Appendix Q  
Columbus Tank Stability Memo

Subject: Scotts Valley Development  
Admiral Callaghan Lane and Columbus Parkway  
Vallejo, California

## **RESPONSE TO PUBLIC COMMENT A17-38: COLUMBUS TANK SLOPE STABILITY**

FIGURE NO.  
**C1**

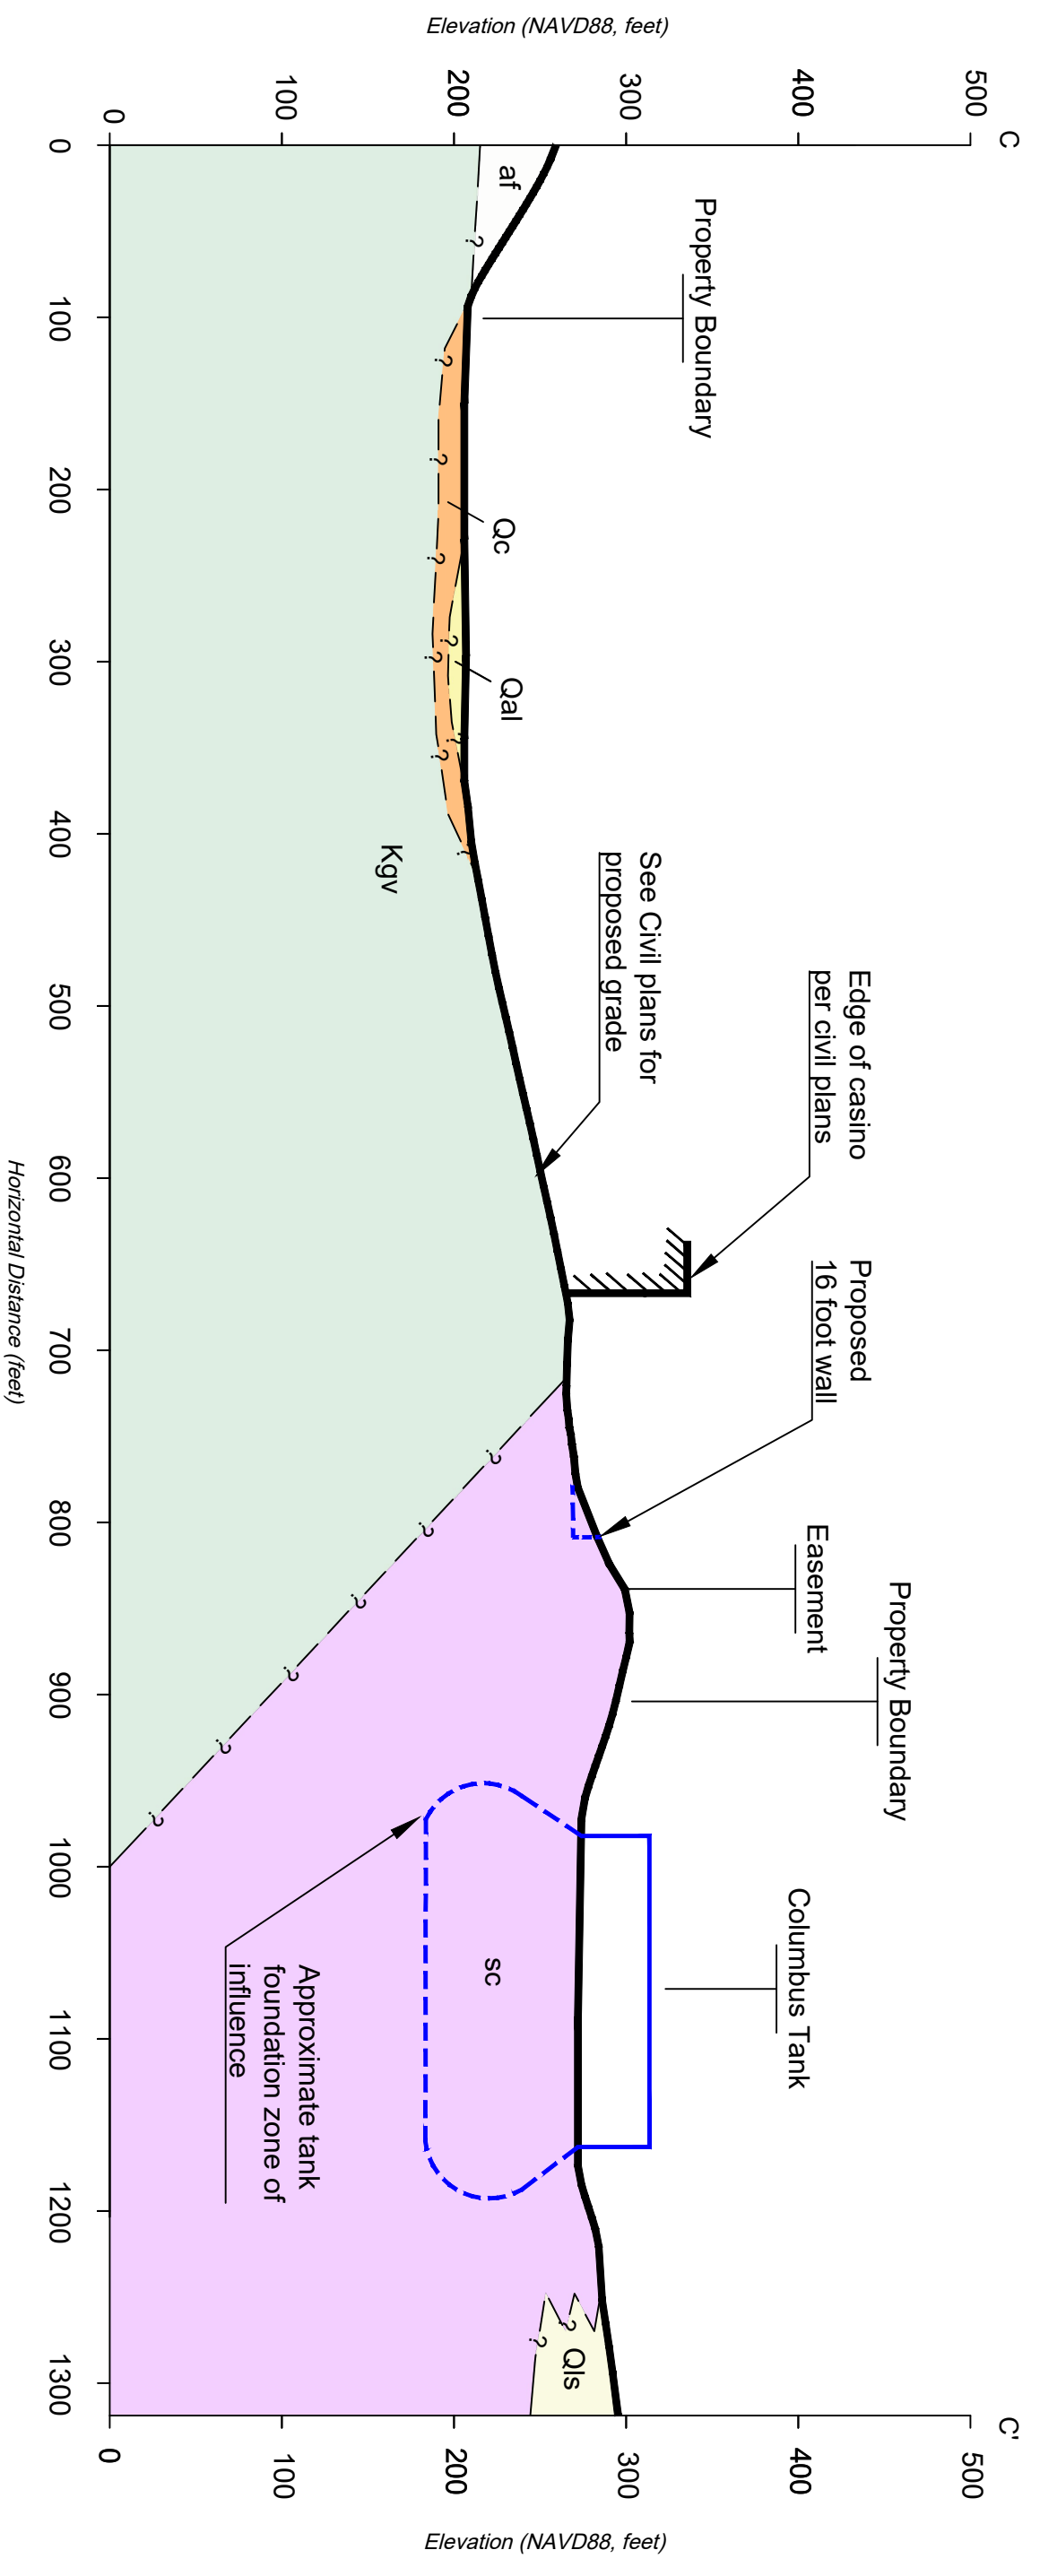
*“The EA does not address how future improvements will affect the Columbus Tank foundation or slope stability or infringe upon the City’s existing slope easement at Columbus Tank. This needs to be studied and all potential impacts identified, and mitigation ensured.”*

- Alternatives A and B: The schematic grading plan for Alternative A (Reference 2) shows a +/- 16-foot-high cut condition retaining wall excavated into the existing slope. In addition, fill and buildings will be constructed down-slope of the tank and wall. The design fill and building loads

downslope of the tank will contribute to increased stability of the slope and tank foundations due to the buttressing effect along the landslide toe. As shown in Figure C1, the edge of the water tank is more than 150 feet away from the proposed retaining wall and the bottom elevation of the wall is located at approximately the same elevation as the bottom of the tank.
